## **Regional District of Okanagan-Similkameen**

### **Construction Services for the Oliver Landfill Organics Composting Facility**

**To:** Posted on BC Bid Website  
**ITT:** RDOS-22-ENG-05  
**Attachments:** Addendum #1

**From:** Scott Garthwaite, ASCT  
**Date:** April 21, 2022  
**Pages:** 11

DRAWING TITLE  
**ELECTRICAL SITE PLAN**

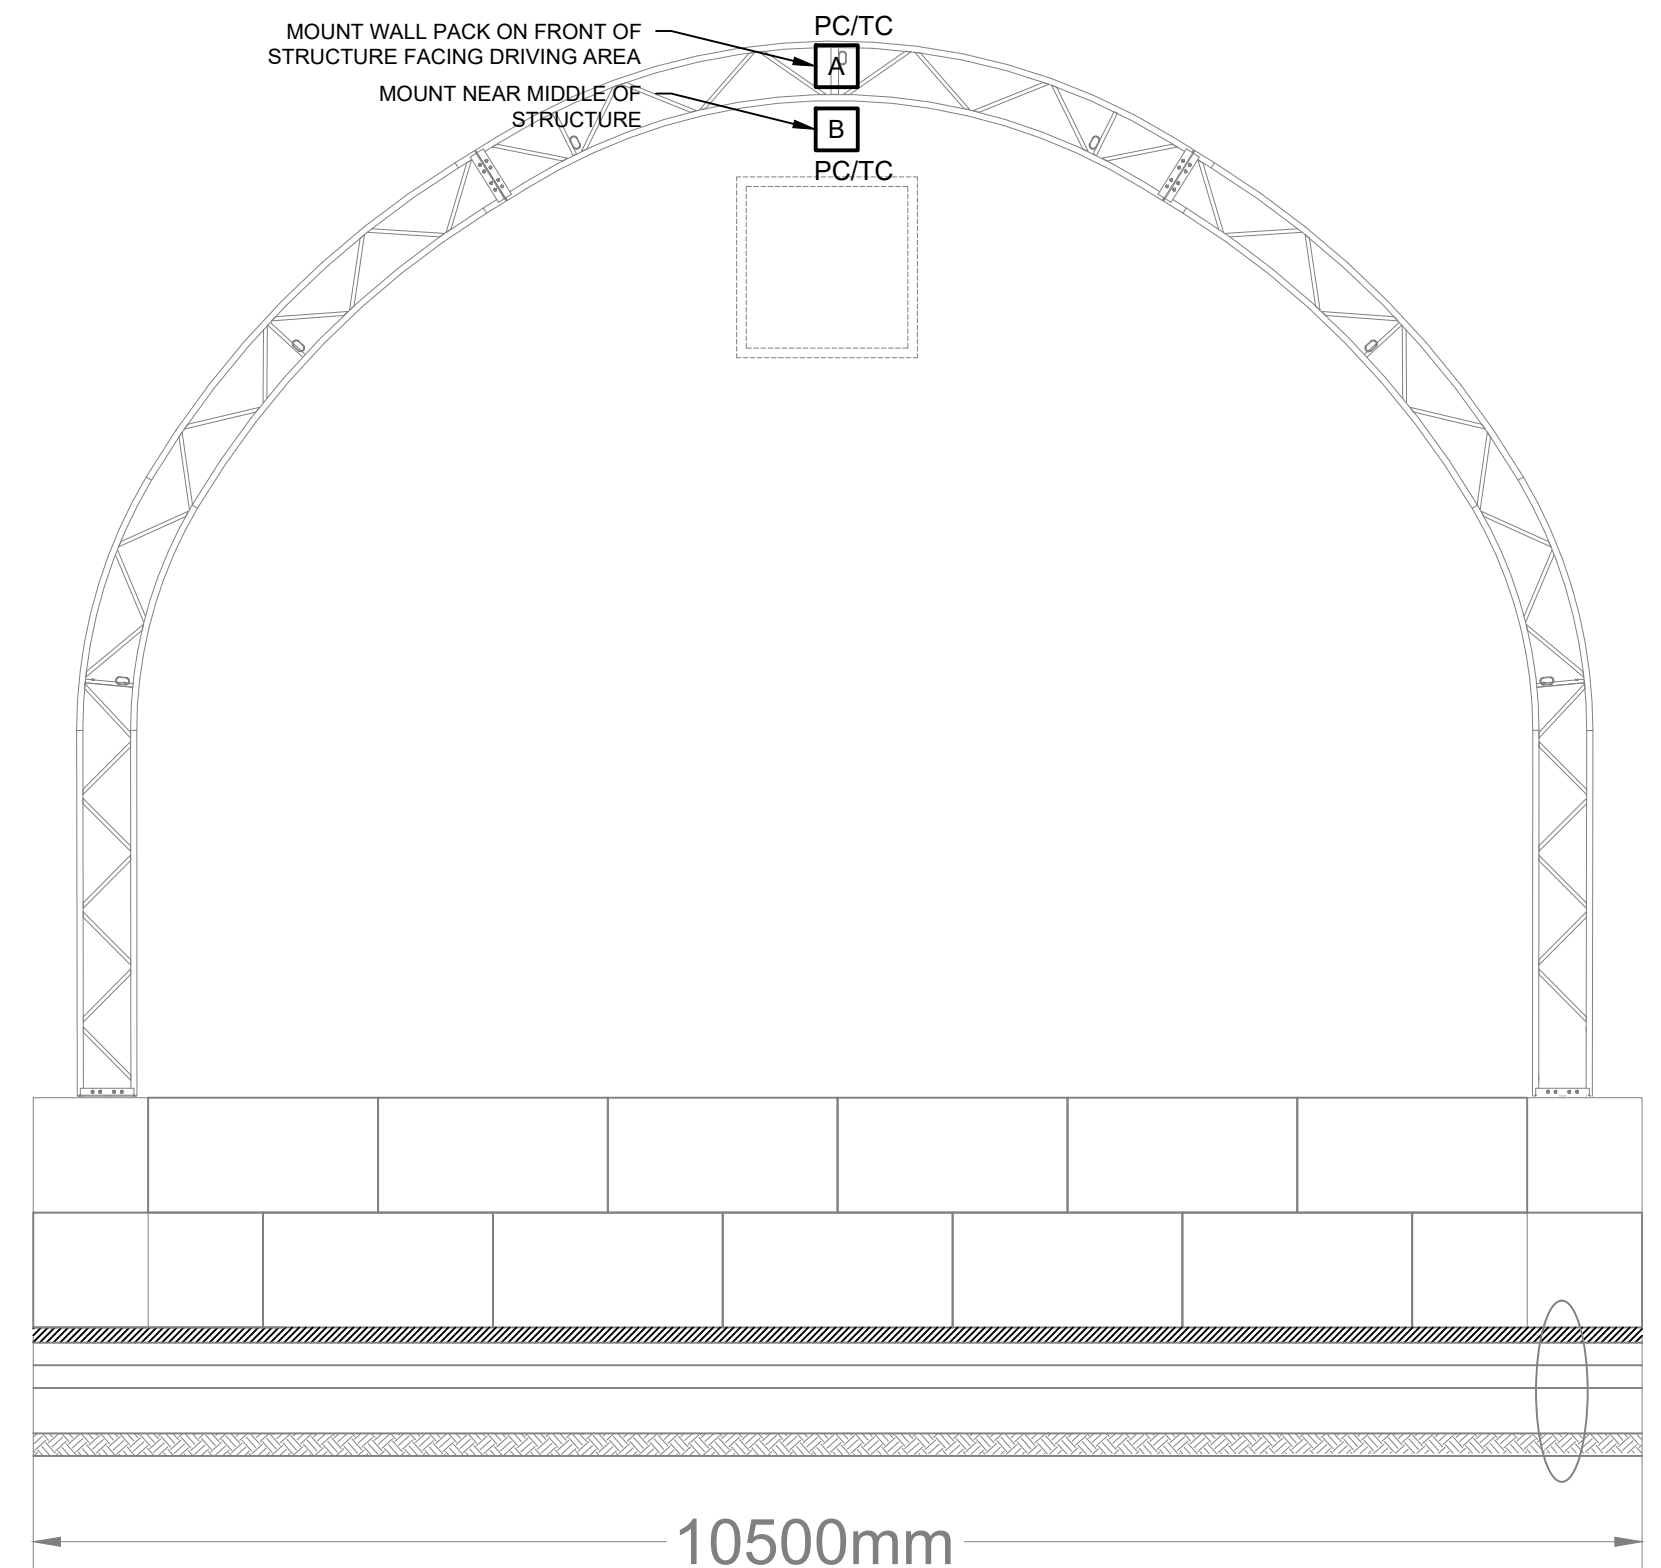
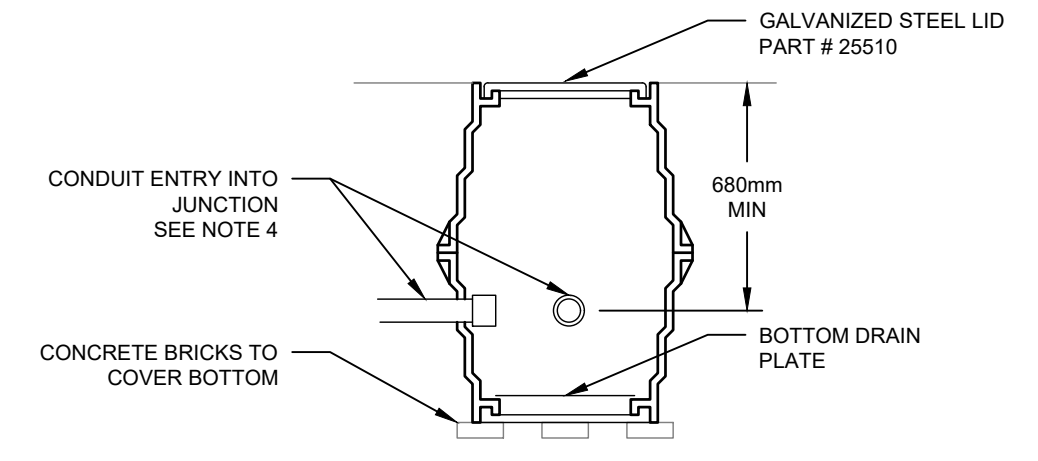
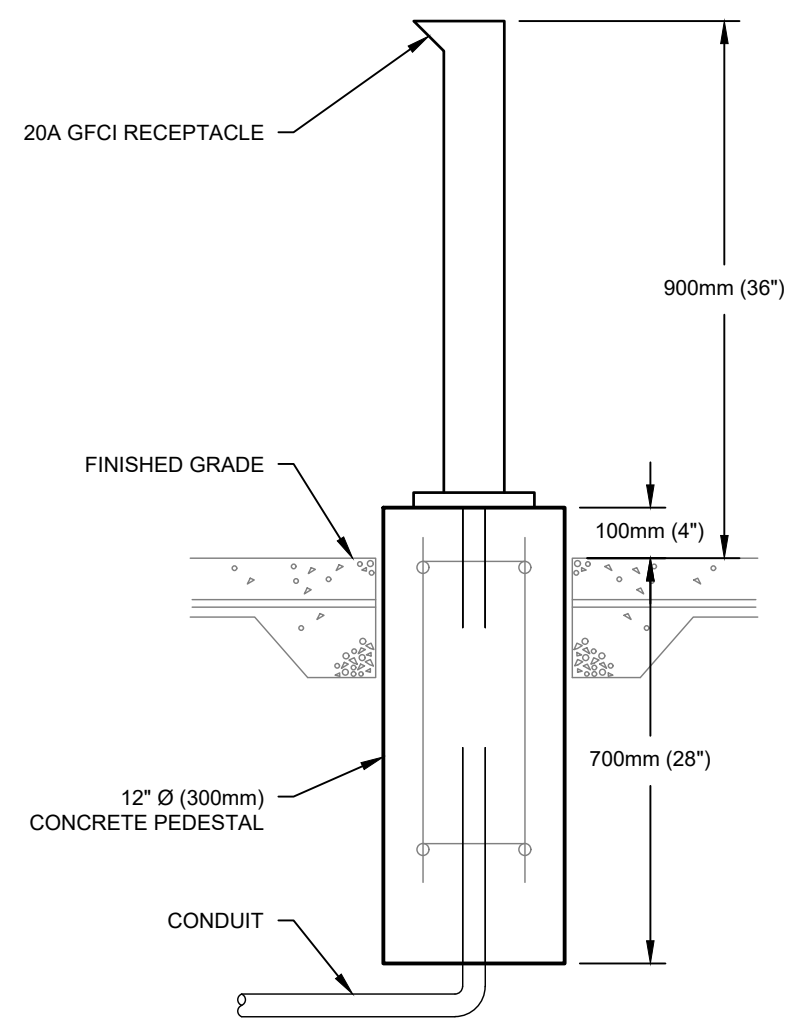
3. PROVIDE COMMUNICATION CONDUIT FROM NEW SERVICE KIOSK TO EXISTING SCALEHOUSE BUILDING. COORDINATE WITH OWNER FOR LOCATION OF COMMUNICATION CONDUIT ENTRY LOCATION.

4. PROVIDE CONDUITS FROM LEACHATE TANK MONITORING PEDESTAL TO LEACHATE TANK.
  5. PROVIDE POWER PEDESTAL NEAR COVERALL STRUCTURE. POWER PEDESTAL IS TO HAVE 20A GFCI DUPLEX RECEPTACLE FOR MAINTENANCE USE. PEDESTAL CAN BE PRE-MANUFACTURED OR ASSEMBLED ON SITE. FEEDER IS TO BE 347V OR 600V. 1Ø AND PEDESTAL IS TO HAVE 2ØVA TRANSFORMER TO PRODUCE 120V.

6. PROVIDE COMMUNICATION CONDUIT FROM THE SCALEHOUSE TO BLACKSAGE RD. CONDUIT IS TO BE 50MM DB2 WITH PULLBOXES INSTALLED EVERY 150M. PULLBOX IS TO BE SAME AS JUNCTION BOX DETAIL. ESTIMATED LENGTH OF CONDUIT RUN IS 1.2KM. REFER TO TRENCH DETAIL FOR COMMUNICATION CONDUIT ON SHEET 101.
